Re: **Joliet Junior College, Illinois Community College District No. 525
Master Facilities Plan Phase 1, Campus Center Building Work, Bid Release 12
1215 Houbolt Road, Joliet, Illinois 60431**

Subject: **Supplement No. 3**

**BIDDING AND CONTRACT REQUIREMENTS
ADDENDUM NUMBER 3**

**JOLIET JUNIOR COLLEGE – BID RELEASE 12
CAMPUS CENTER
Interior Architecture**
Architect's Project Number: 208069.00

ASK-40

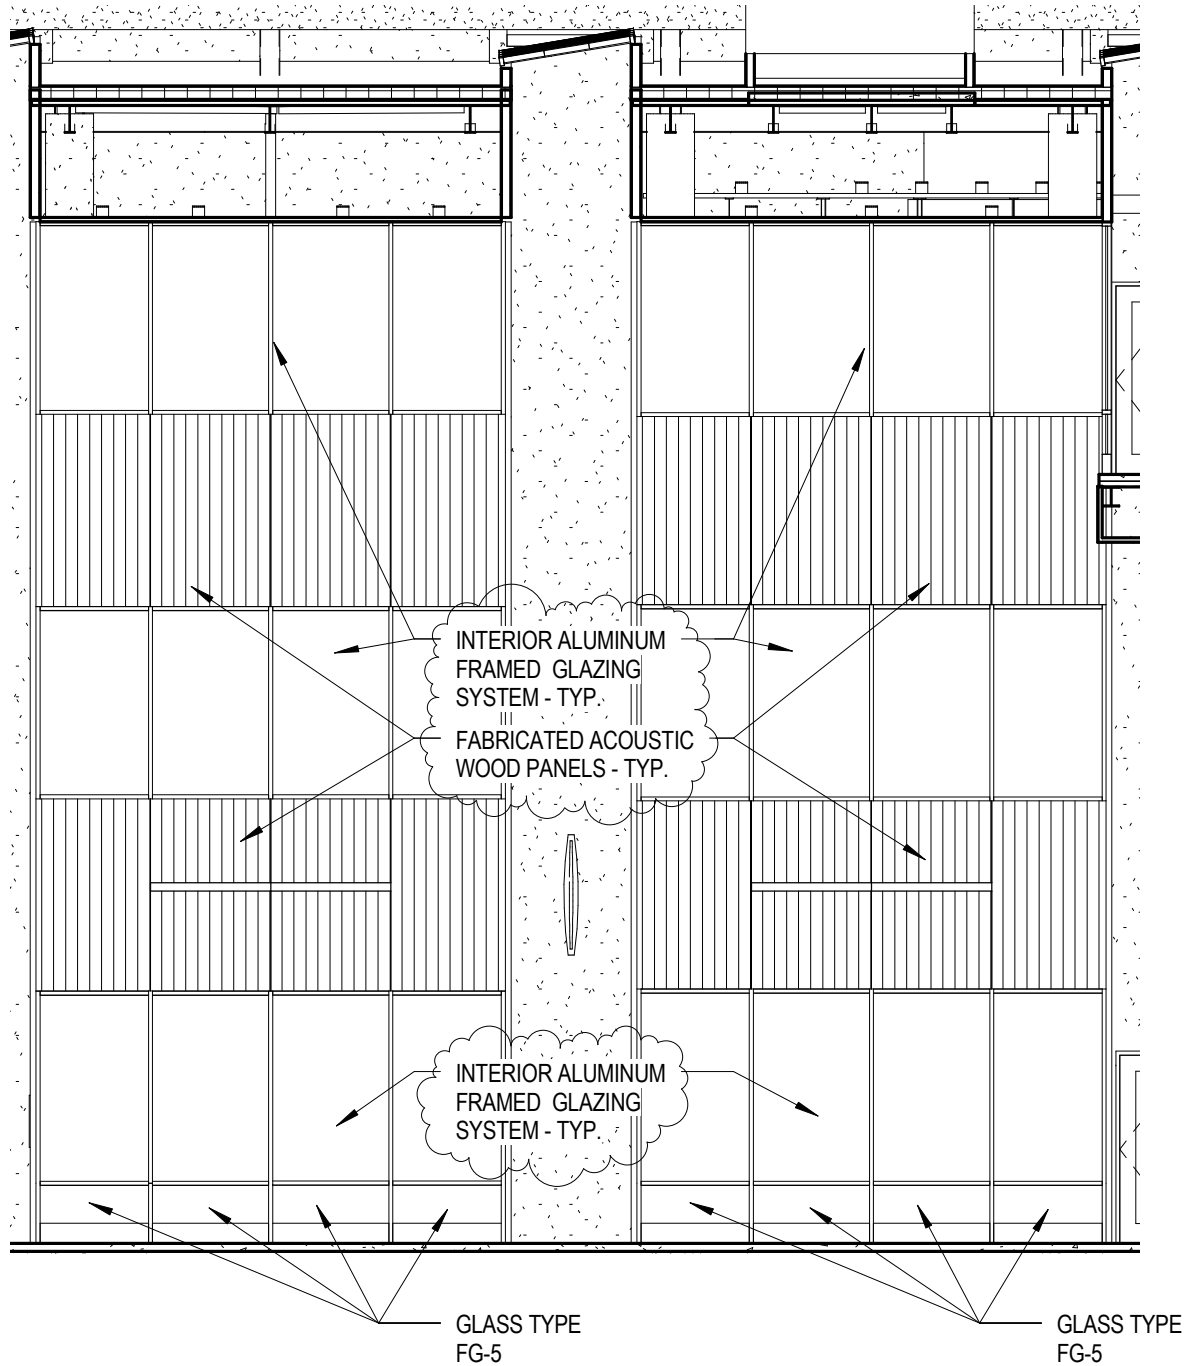
- d) Drawing A4.10, Detail 1: ADD notes as shown in attached sketch ASK-40. These notes also apply to materials shown in details 2 and 4 on this drawing.
